## ADDENDUM NO. 2

**TO: PLANS AND SPECIFICATIONS FOR STATE OF MISSOURI**

**Sewer Renovations  
Mark Twain State Park  
Florida, Missouri  
PROJECT NO.: X2333-01**

SHEET NUMBER:  
**C-101**

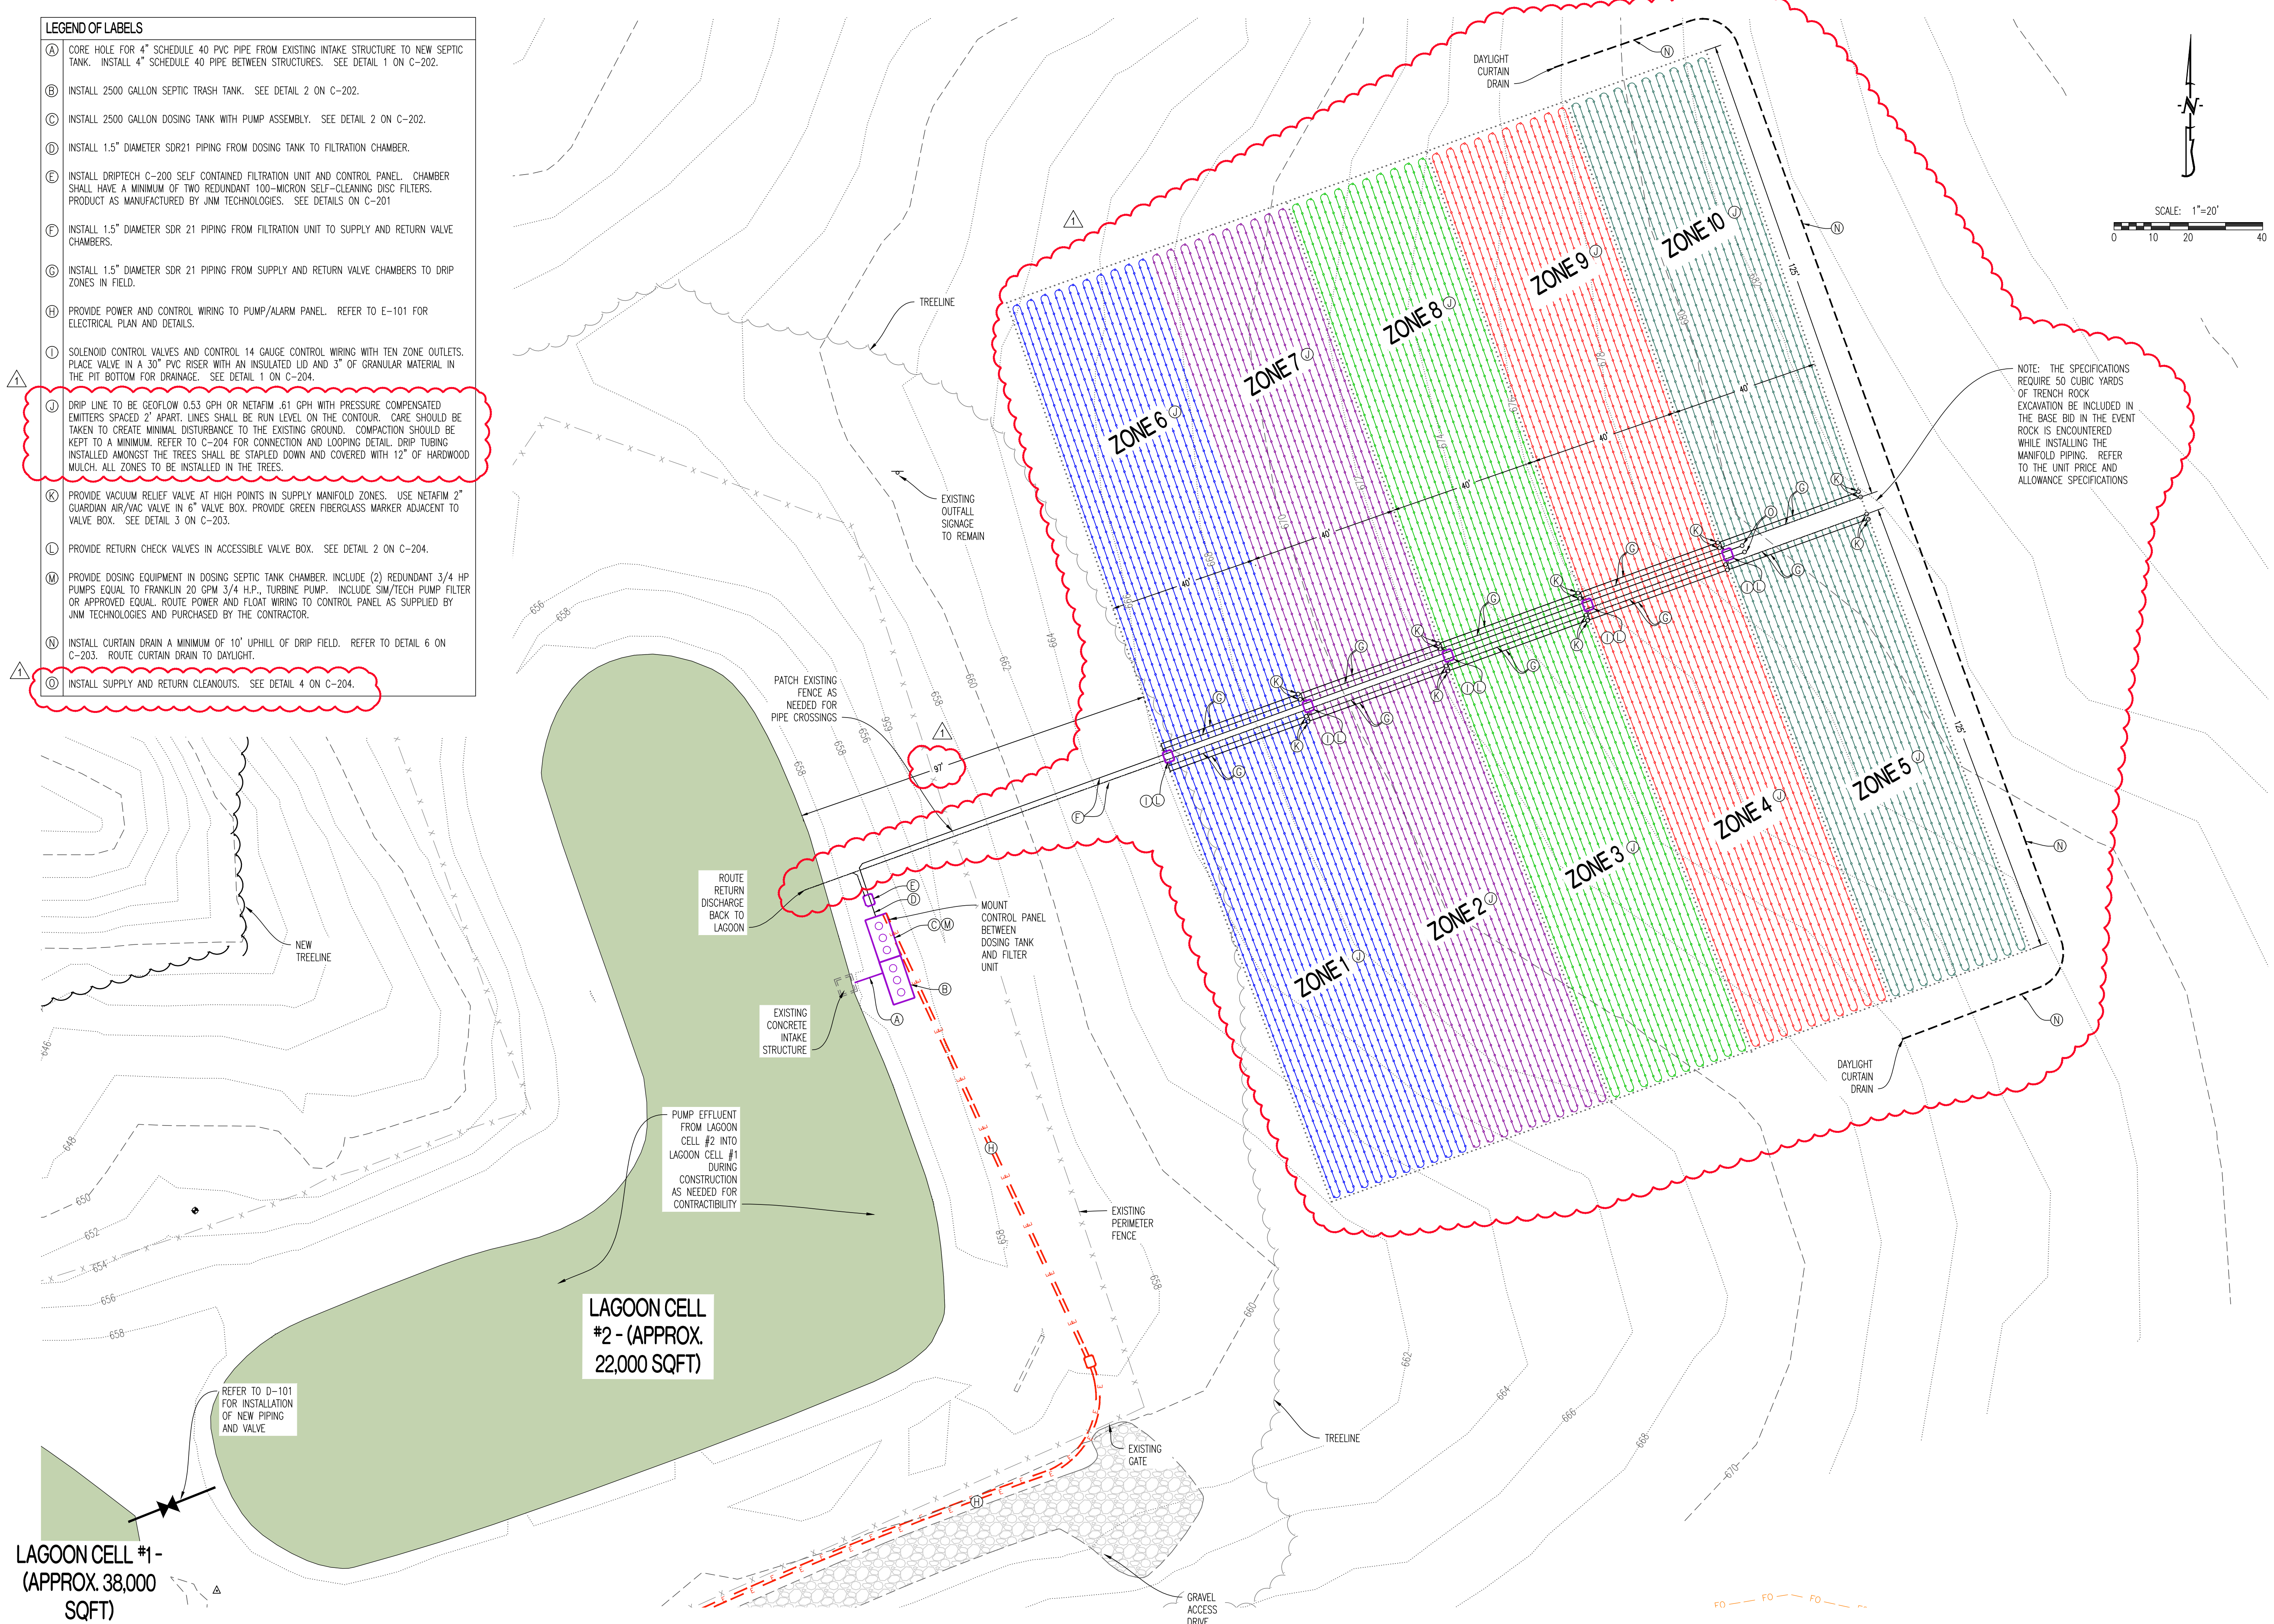
1. Per coordination with the manufacturer, the drip field has been split into 10 zones instead of 5 zones for efficacy of the controls and equipment.
2. Due to concerns with some rock fragments, the drip field has been moved entirely within the trees to allow for all tubing to be laid on the ground. Key note J has been adjusted accordingly.
3. Main and sub-manifolds adjusted to match details on C-204
4. Supply and return main cleanouts added. Key Note “O” added to match detail 4 on C-204.

07 DRIP-TECH C200 - ZONE SCHEMATIC  
SCALE: NONE

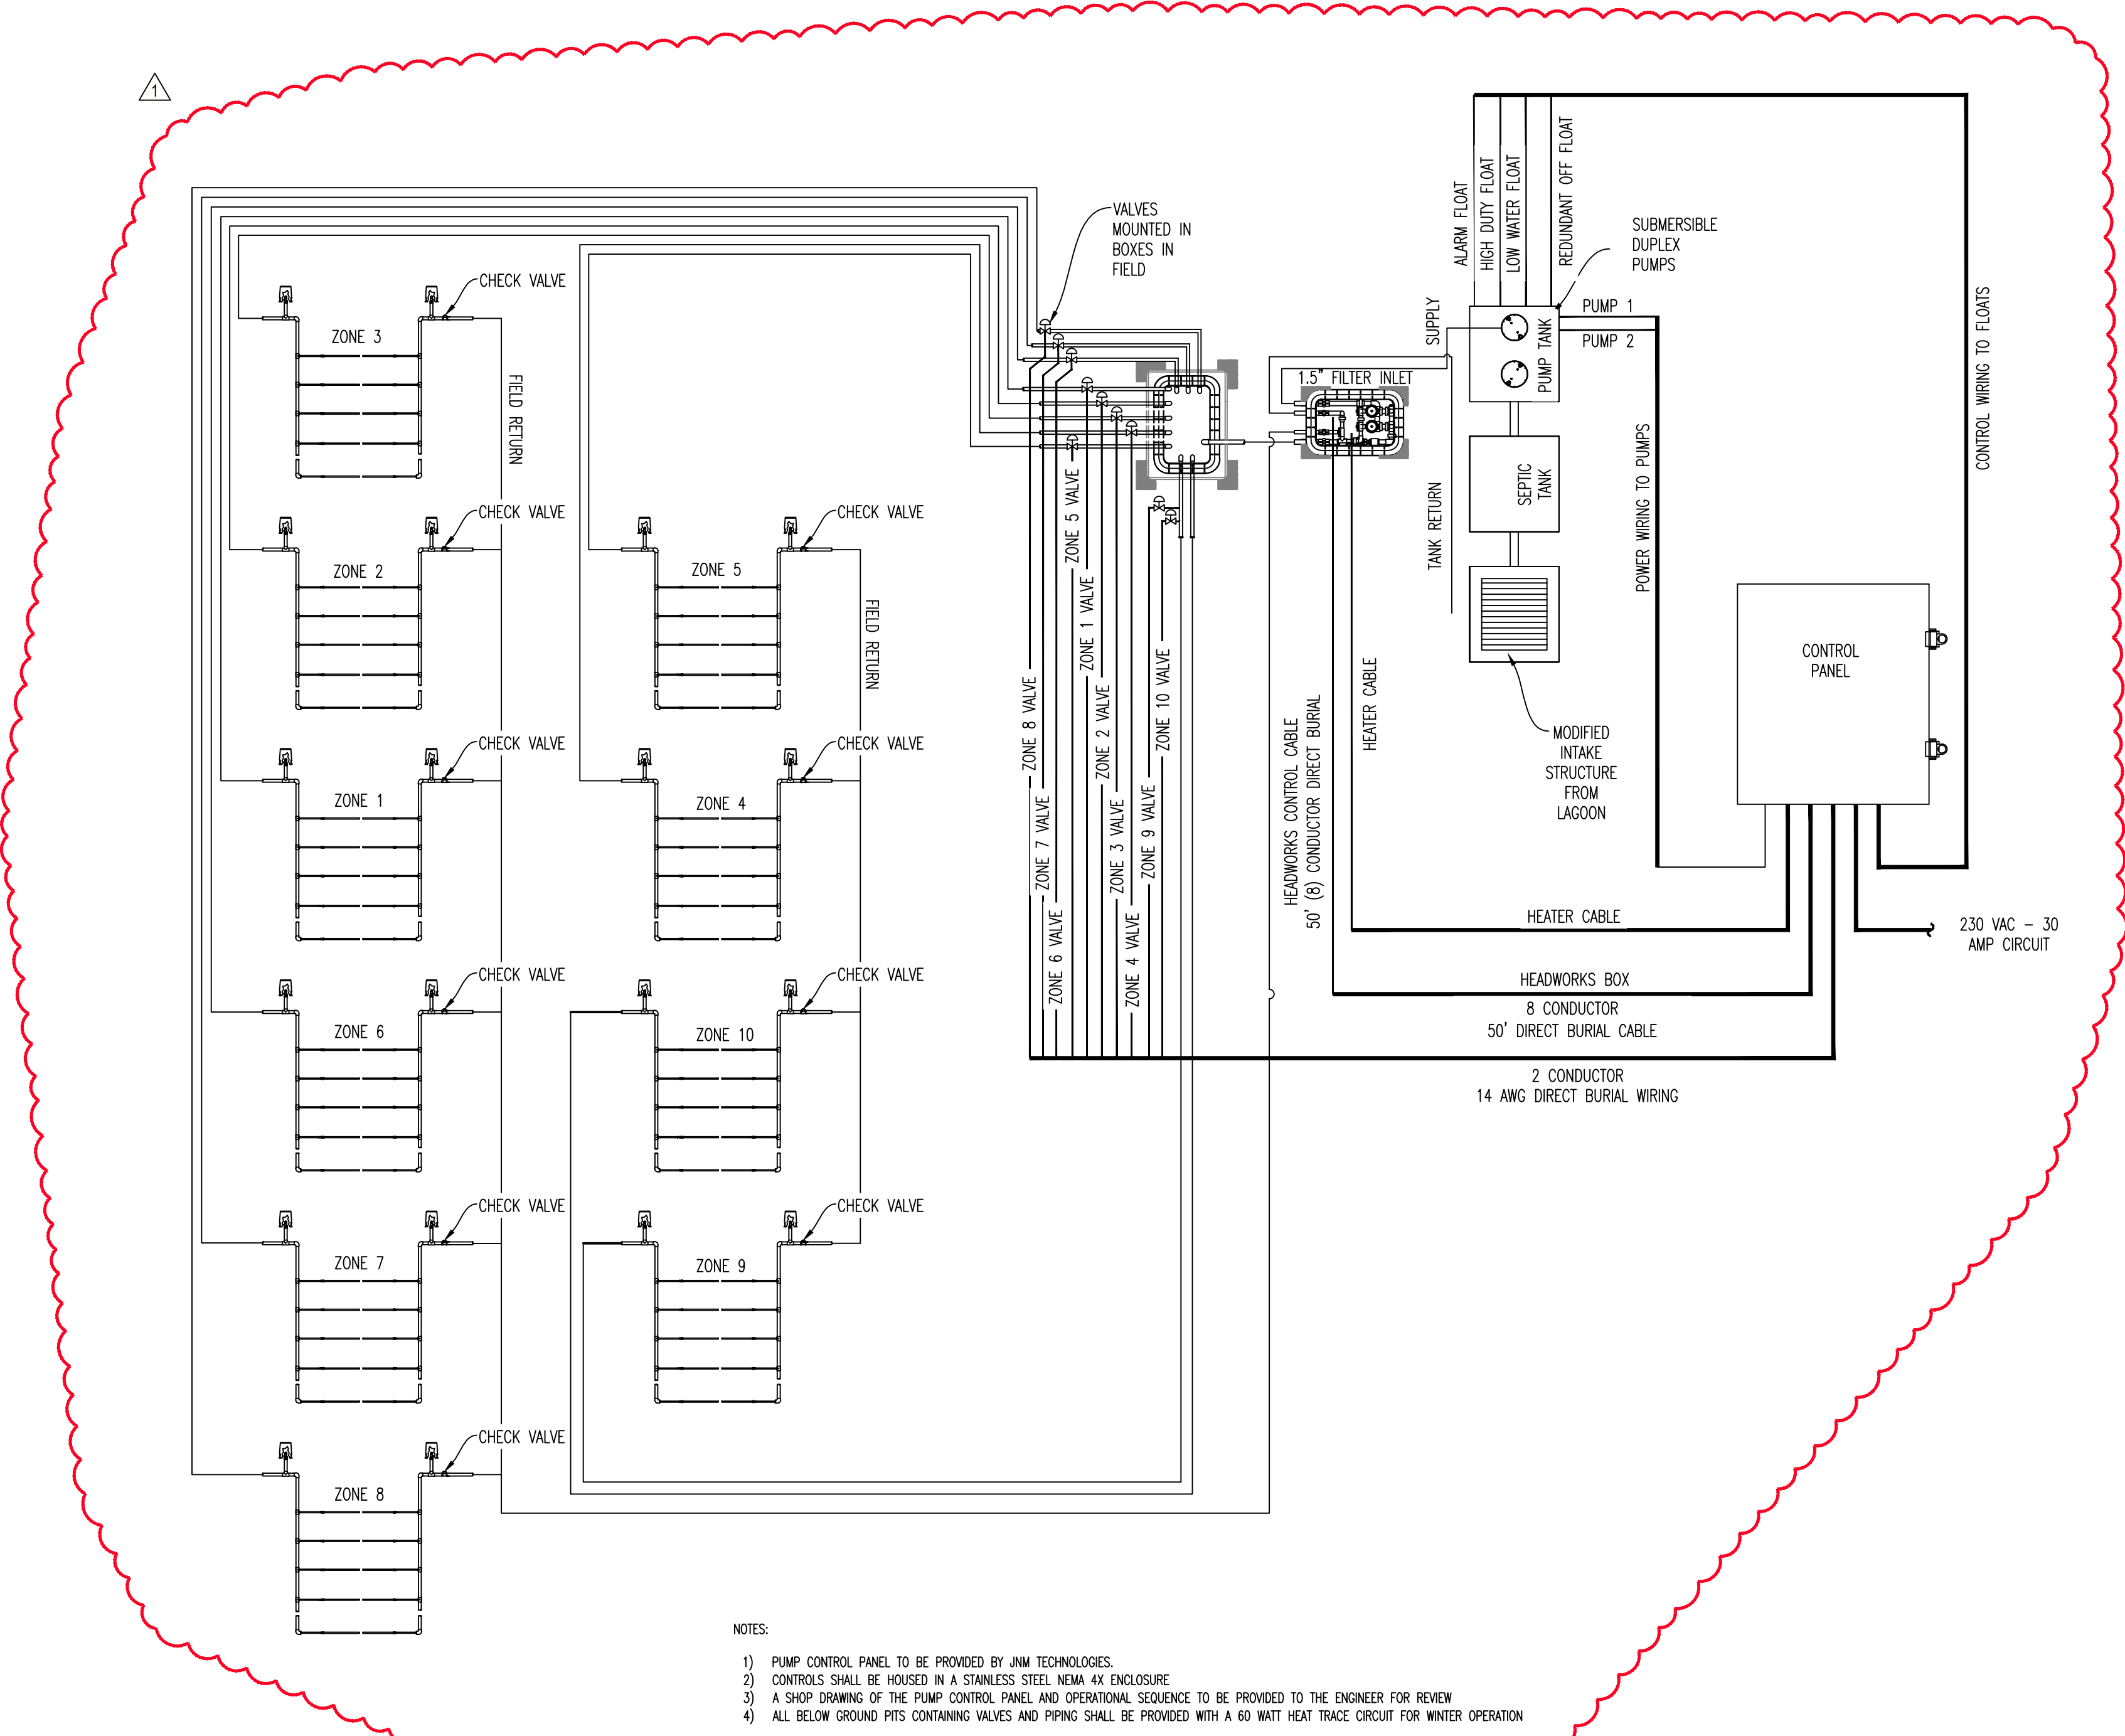
1. Detail 7 updated to show 10 zones instead of 5 zones.

04 CLEAN OUT DETAIL  
SCALE: NONE

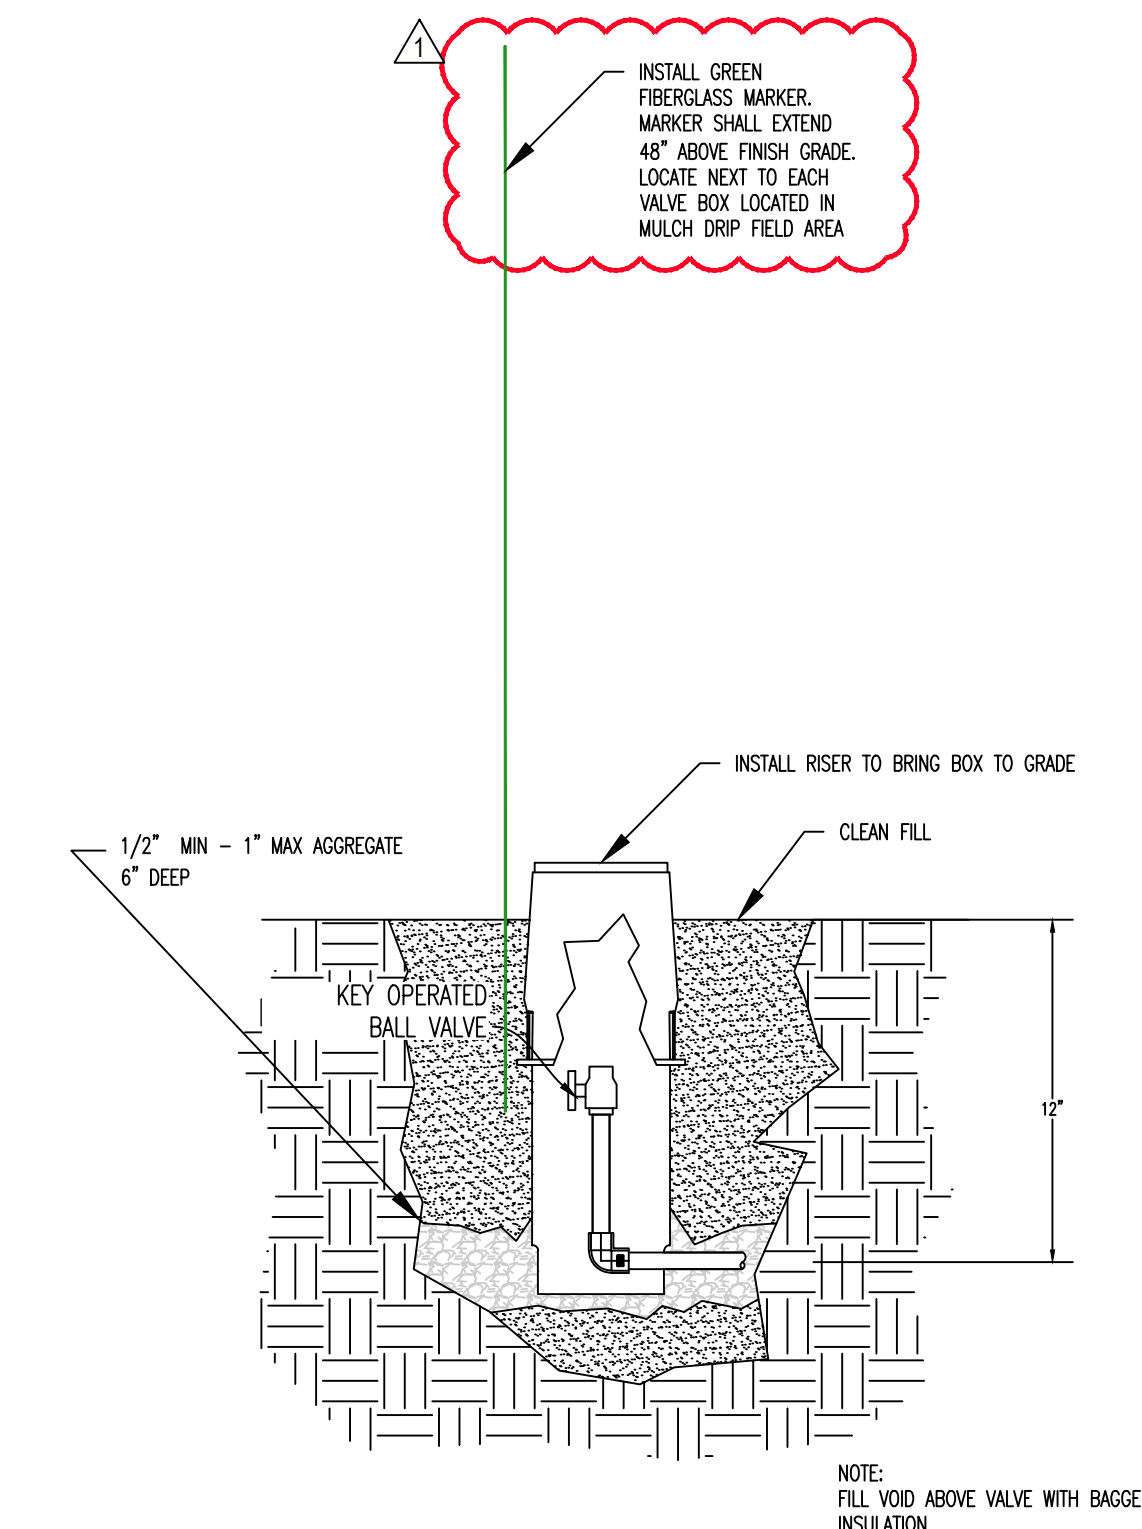
1. Detail 4 updated to show required fiberglass marker
